Ministry of Northern Development, Mines, Natural  
Resources and Forestry

ERO Postings:  
No. 019-4363  
No. 019-4365

RE: Report ADM-2021-063 St. Marys Cement Inc. Canada – Proposed changes to the conditions of an ARA licence

SUBJECT: St. Marys Cement Inc. (Canada) - Changes to the conditions of a licence to operate a pit or quarry: ERO No. 019-4363 and ERO No. 019-4365

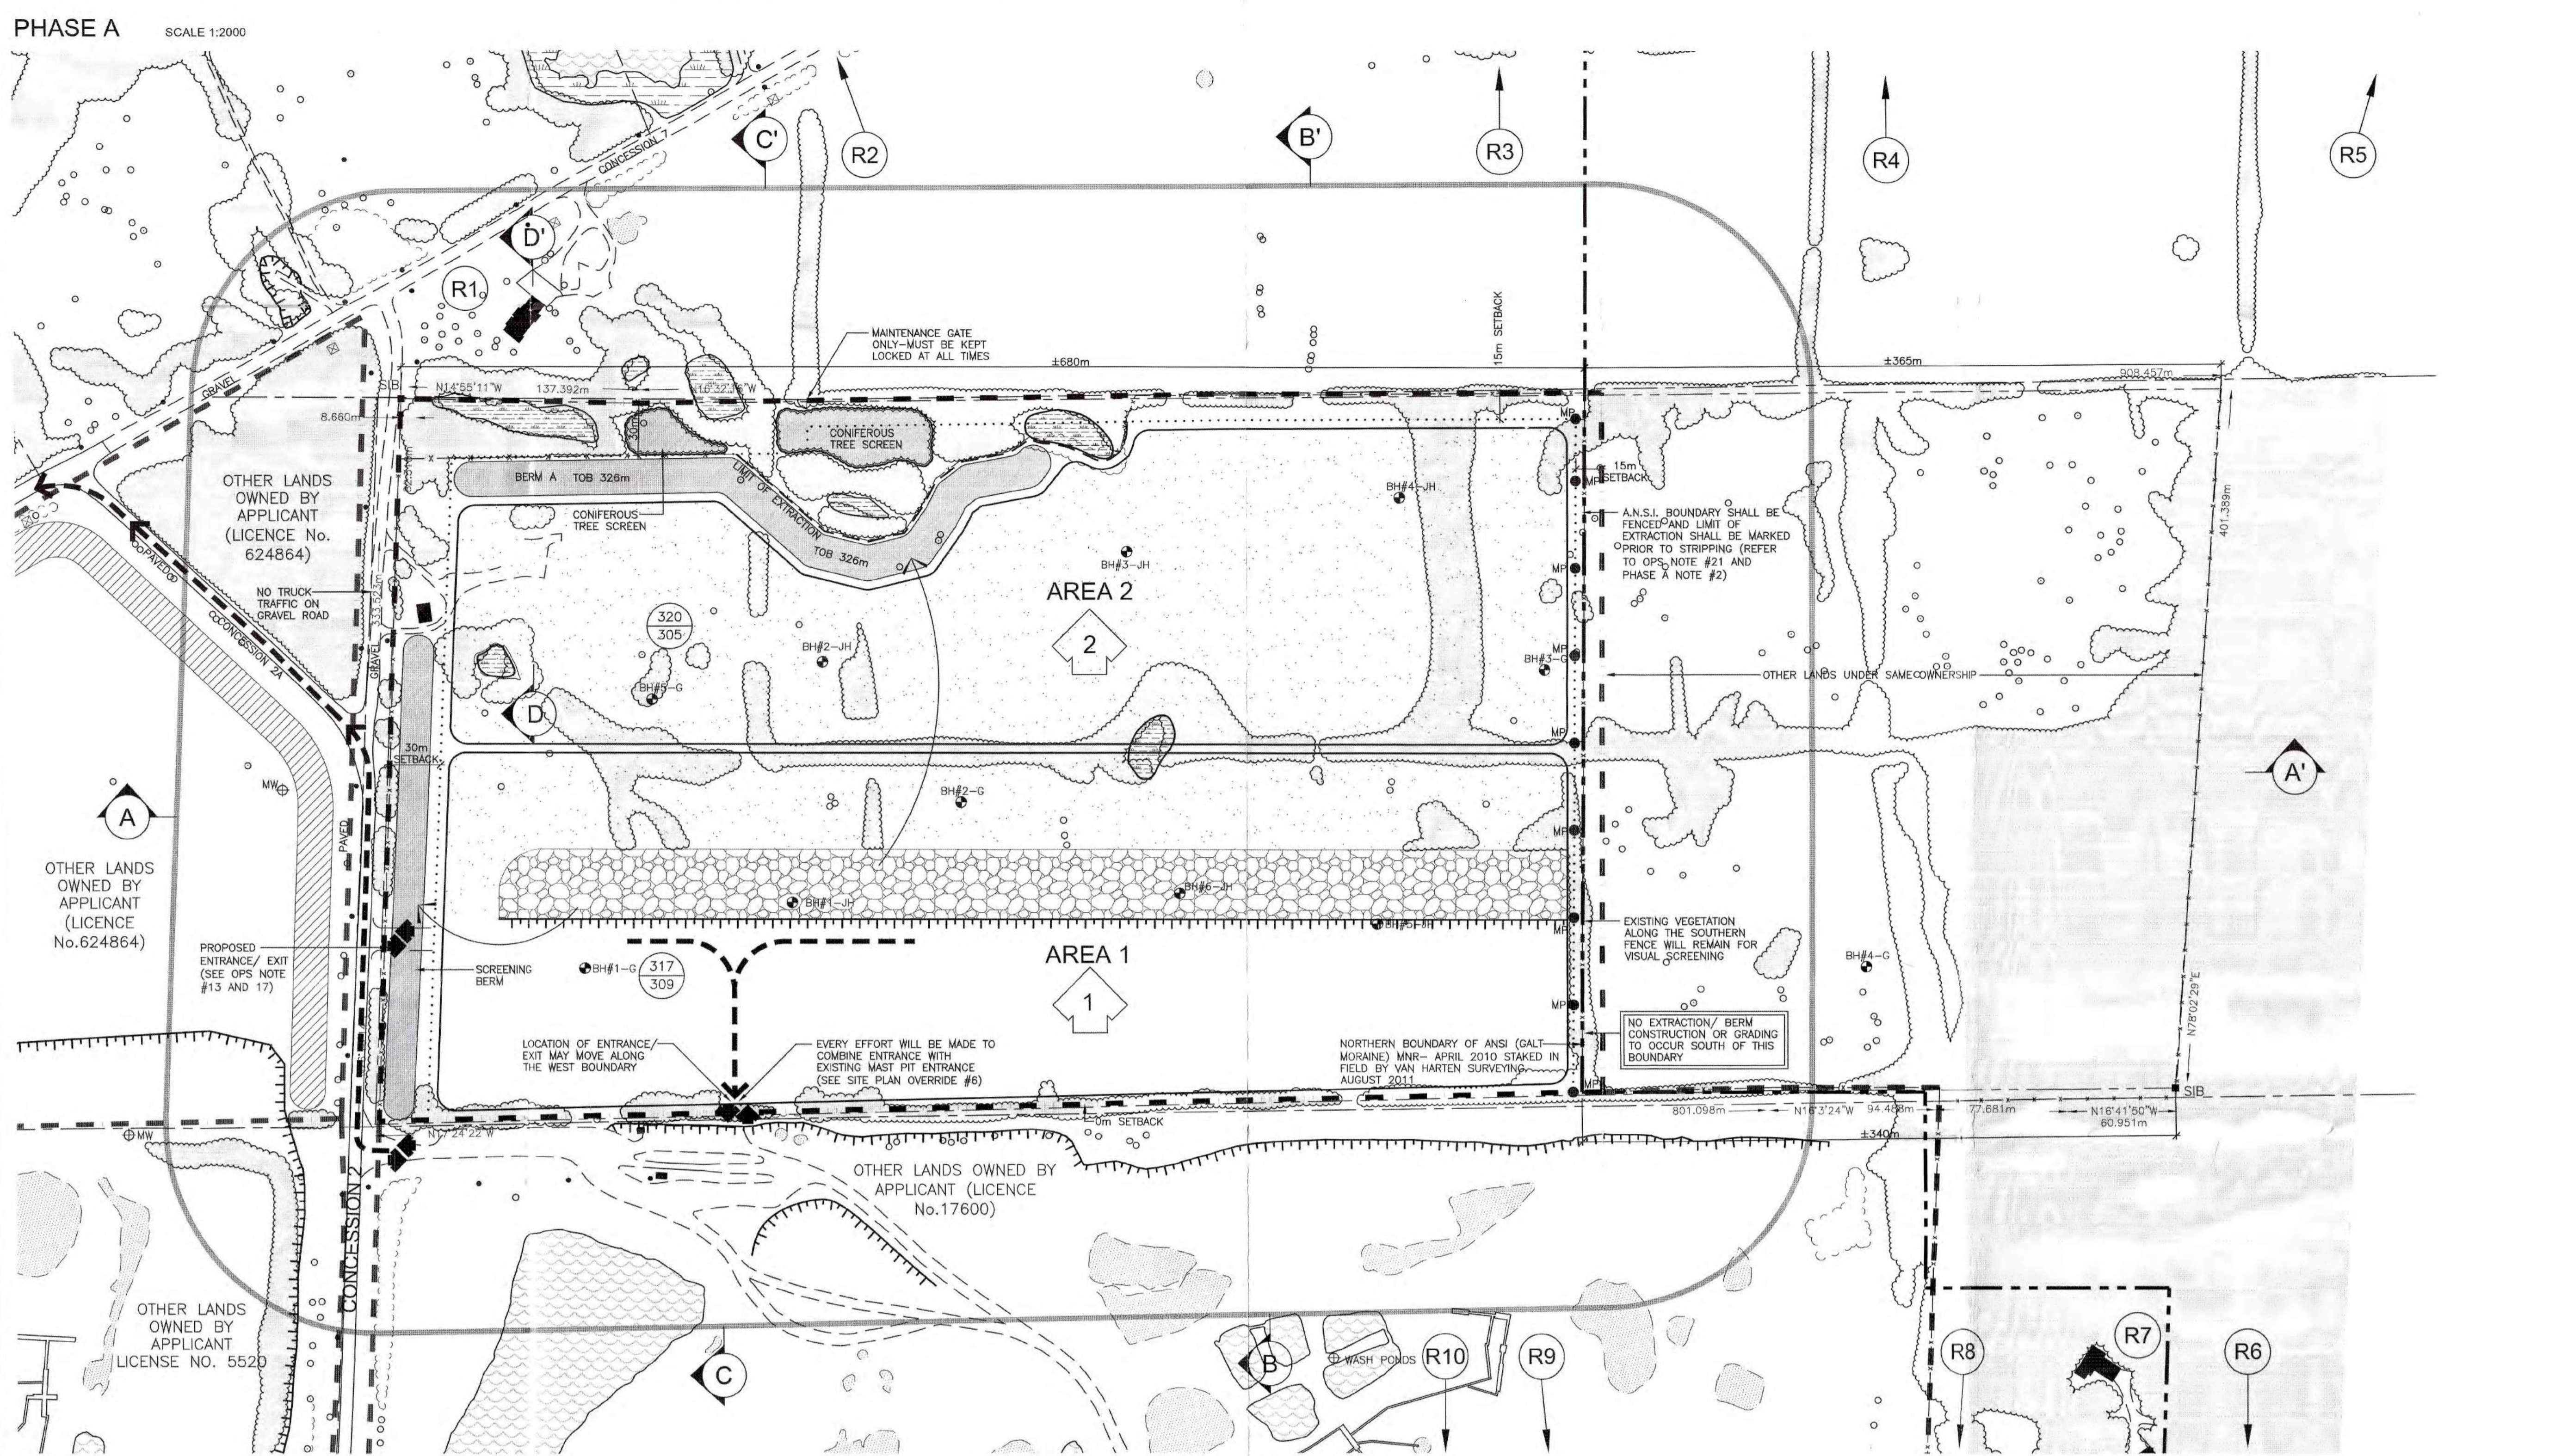
Below are photographs of the road crossing at the CBM site on Concession 2 where no conveyor system is used:

Staff recommend that the operational plan be adhered to with respect to a conveyor system being the primary method of transporting material, and form part of the comments submitted on behalf of the Township.
